MONTGOMERY COUNTY HISTORIC PRESERVATION COMMISSION
STAFF REPORT

Address:	10201 Menlo Ave., Silver Spring	Meeting Date:	9/9/2020
Resource:	Vacant Lot Capitol View Park Historic District	Report Date:	9/2/2020
Applicant:	Minter Farnsworth	Public Notice:	8/26/2020
Review:	HAWP	Tax Credit:	n/a
Case Number:	31/07-20F	Staff:	Dan Bruechert
PROPOSAL:	Tree Removal

Figure 2: Partial site plan showing the location, size, and species of the proposed tree removal.

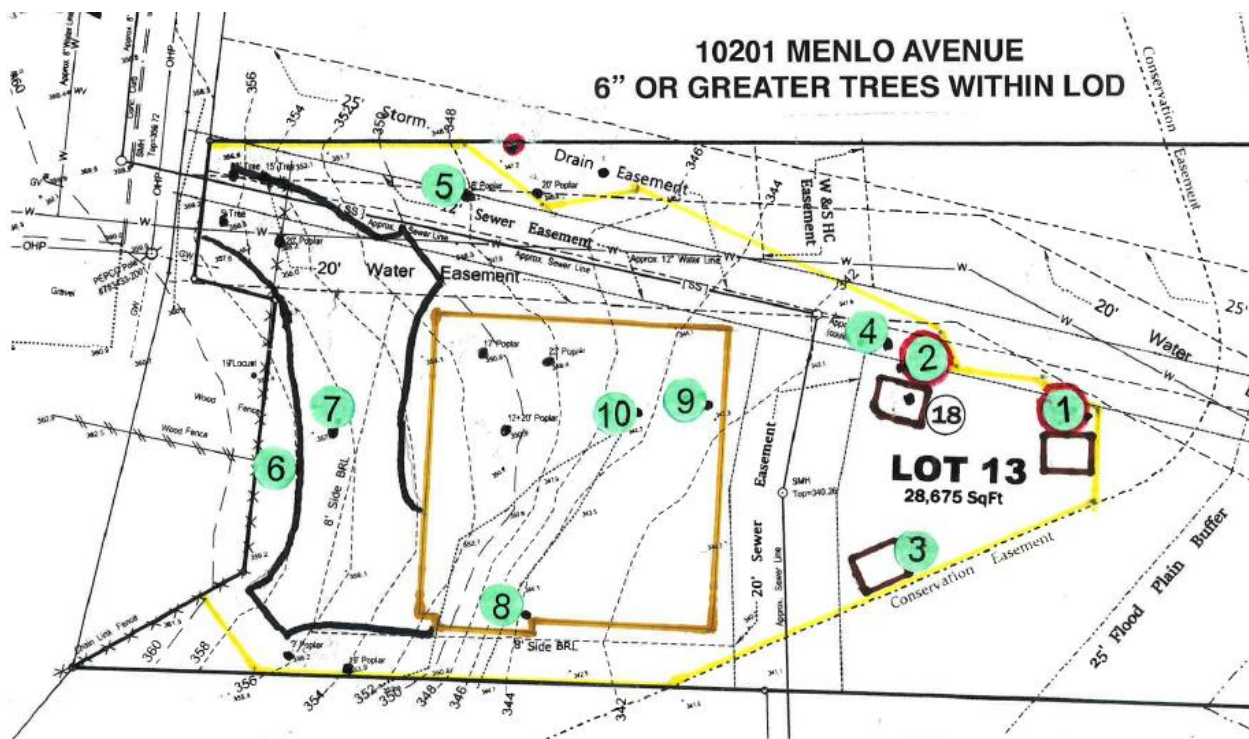
Trees identified as 8, 9, and 10 are all within the footprint of the approved house. The applicant asserts that two of the trees were smaller than 6” d.b.h. when the 2017 Prelim was submitted; and the third tree was obscured by bamboo and missed by the applicant’s arborist. Regardless of the tree growth and the omission by the arborist the trees exceed 6” and require a HAWP. In April 2019 the HPC agreed with Staff’s finding that the only location a house could be placed on the lot (due to the restrictions of the conservation easement and several utility easements along with zoning requirements) is the location of the approved house. For the HPC to not approve the tree removal would frustrate the approved HAWP and Staff finds would violate 24A-8(b)(5), depriving the applicant of the reasonable use of the property. Staff recommends the HPC approve the removal of trees 8, 9, and 10 of the submitted tree survey.

Trees 6 and 7 are in or immediately adjacent to the proposed driveway. Due to the unique layout of this lot, with the only access point to Menlo Ave. at the northwestern corner of the lot, Staff finds the driveway can not be located in any other location on the site. Staff finds that trees 6 and 7, like the trees discussed above, need to be removed so that the site has vehicular access. Staff recommends the HPC approve the removal of trees 6 and 7 under 24A-8(b)(5). Staff also notes that tree 6 is identified in ‘poor health’ and while it is not a hazard yet if its health continues to degrade its removal will be required as a hazard without the HPC’s approval.

Trees 1, 2, 3, and 4 are located to the rear of the lot and are not visible from the right of way. Trees 1 and 2 will be retained in their location. Tree 3 is in the location of one of the three proposed dry wells on the site and is one of the trees the applicant identified as less than 6” at the time of the original submission. Tree 4 is a 10” d.b.h. spruce tree that is in poor health due to a spider mite infestation. Staff finds that tree 3 is barely above the 6” threshold and is in a location that is not visible from the public right-of-way. Its removal will not impact the historic character of the site or the surrounding district. Additionally, tree 3 is in the location of one of the proposed drywells. While this dry well could be relocated, that would expand the limits of disturbance and increase the potential erosion on site. Tree 4 is in poor health and only has needles at its crown. Staff finds that this tree will likely continue to degrade and become a hazard. Staff recommends the HPC approve the removal of trees 3 and 4 under 24A-8(b)(2), (4), and (5).

Tree 5 is a Tulip Poplar that the applicant contends was less than 6” d.b.h. at the time of the original submission. Based on the soft wood and quick growth of the species, Staff concludes this was likely the case. The location of this tree is near the turn-around for the previously approved driveway and in the middle of the approved timber terraces. In Staff’s discussions with the applicant, the applicant identified the approved on-site re-grading and terracing as a method to limit runoff and erosion into the creek; a concern voiced by many members of the community in the various Preliminary Consultations, HAWP hearings, and administrative appeals. Staff recommends the HPC approve the removal of Tree 5 under 24A-8(b)(2) and (d).

In summary, the applicant will remove a total of eight trees of the ten trees within the limits of disturbance. Staff finds approval of removing the trees that are either in the house or driveway footprint or immediately adjacent (Trees 5 – 10) should be approved under 24A-8(b)(5); as the site could not be developed without removing them. Tree 3 is not visible from the right of way and is in the location of one of the approved drywells. Staff finds this tree is not visible from the surrounding district and recommends its removal under 24A-8(b)(1). Finally, Tree 4 is only partially visible from the right-of-way and is in poor health. Staff recommends the HPC approve the removal of this tree under 24A-8(b)(1) and (4).

Staff recommends that the Commission **approve** the HAWP application under the Criteria for Issuance in Chapter 24A-8(b)(1), (2), (4), (5) and (d), having found that the proposal will not substantially alter the exterior features of the historic resource and is compatible in character with the district and the purposes of Chapter 24A;

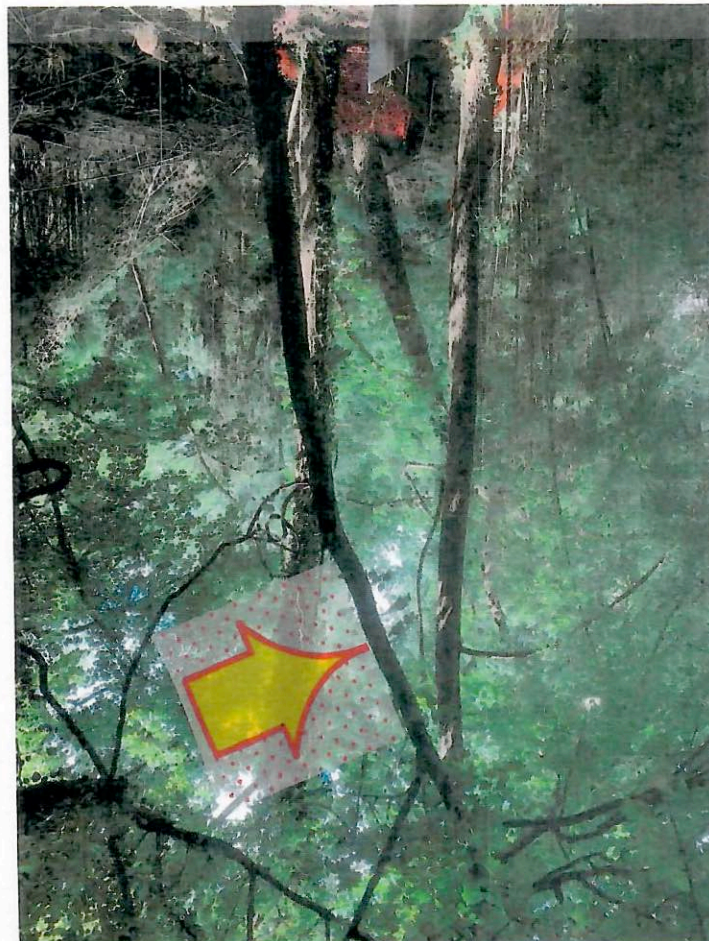
TREE #3
6.25" Tulip Poplar
Not planning to save - Dry well location
Encroaching into the area of replanting a willow oak

TREE #4
10" Spruce
Not planning
to save due to
poor health
Needlecast and
Spider Mites

TREE #5
8.5" Tulip Poplar
6" on 2017 NRI
Not planning to
save due to
leaning over
neighbor's
property and
in fill area for
driveway

TREE #6
8" Maple
Not planning to save
due to poor health
and within driveway

TREE #7
7" Maple
6" on 2017 NRI
Not planning to
save due to
location within
the driveway

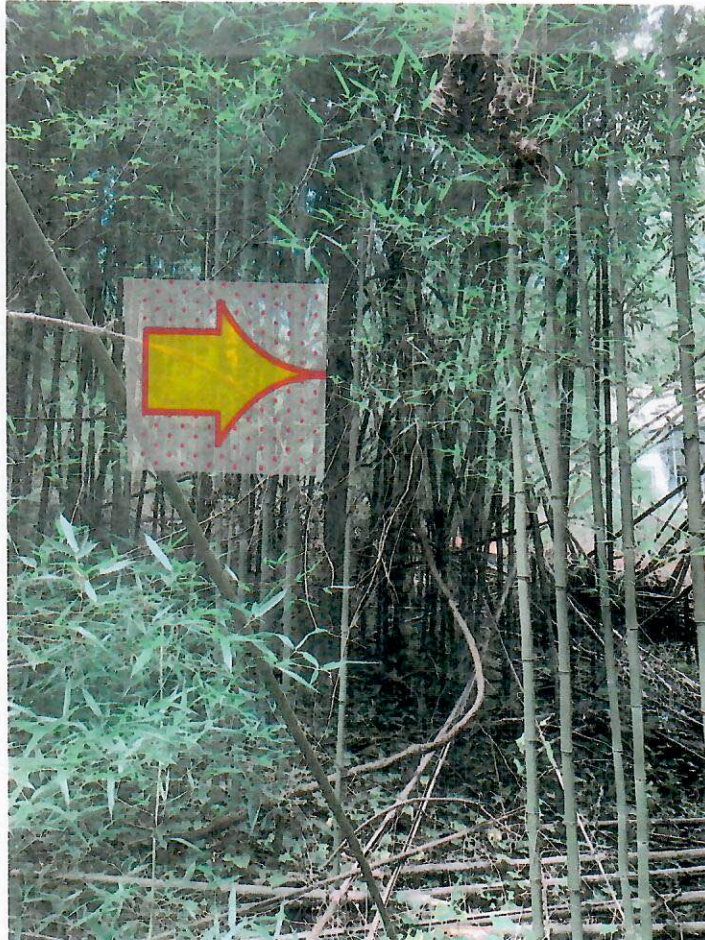
TREE #8
9" Maple
Not planning to save
due to location
within the house, deck and
retaining wall construction

TREE #9
10.5" Black Locust
Not planning to
save due to
leaning toward
neighbor's house
and within the
house, deck and
retaining wall
construction

TREE #10
8" Oak
6" or less at
2017 HAWP
Not planning
to save due to
within the
house, deck
and retaining
wall construction
